1 Proposed Contiguous Elevation D-D 1:200 Part A

Rev.	Date	Description	By	Check
001	2024-04-12	ISSUED FOR RFI	AN	AN
002	2024-04-12	ISSUED FOR RFI	AN	AN

Company that completed this drawing: MOLA
 Project: QUANTAN DEVELOPMENT PHASE 2
 Location: QUANTAN, ADAMSTOWN, VIC, AUSTRALIA
 Date: APR 22
 Scale: 1:200 (1:500@A0)
 Drawing No: LC-202-SW-XX-DR-MOLA-A5-0207

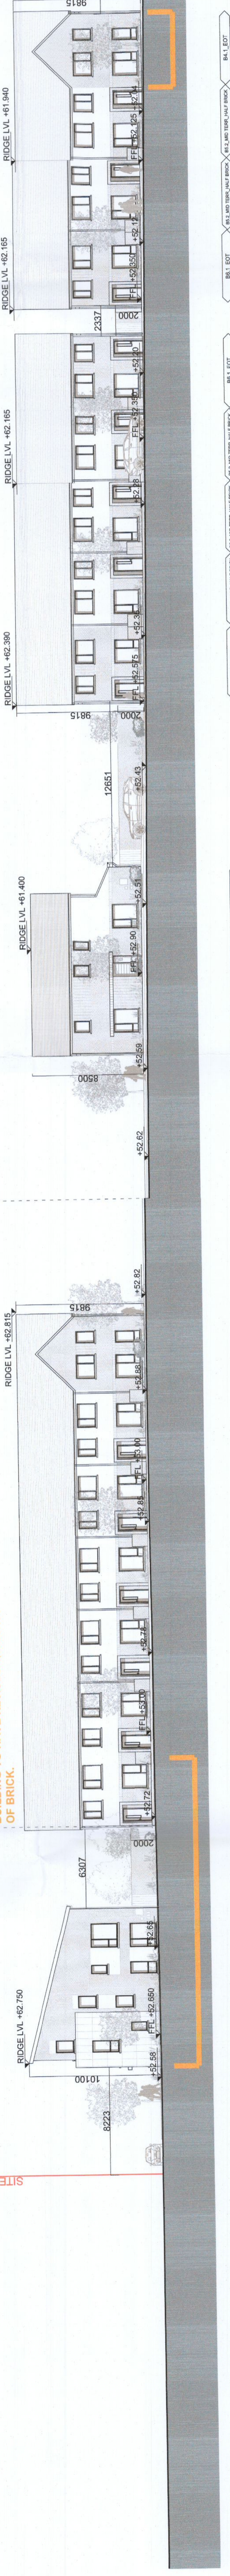
RFI 3B: LANDMARK UNIT (A5-43) REVISED TO IMPROVE WAYFINDING

RFI 1: UNITS ADJACENT TO LANDMARK BUILDING TO HAVE REVISED QUANTITY OF BRICK.

RFI 3B: HOUSE A5-6 CHANGED FOR PASSIVE SURVEILLANCE. FRONT ENTRY UNIT PREVIOUSLY PROPOSED IS NOW SIDE ENTRY.

RFI 3A AND RFI 3B: BLOCK A5 REVISSED TO IMPROVE WAYFINDING. UNITS ADJACENT TO WESTERN PARK AND TO ACCOMMODATE UPGRADED EAST-WEST LINK. 3-BAND DUPLEX BLOCKS INCLUDED TO RETAIN THE SAME DENSITY. UNITS ADJACENT TO LANDMARK BUILDING TO HAVE REVISED QUANTITY OF BRICK.

NOTE: LANDMARK DUPLEX UNIT (A3-1213) TO IMPROVE WAYFINDING

BLOCK A3 UPDATED TO ACCOMMODATE THE DUPLEX UNITS.

RFI 3B: HOUSE A5-11 CHANGED FOR PASSIVE SURVEILLANCE
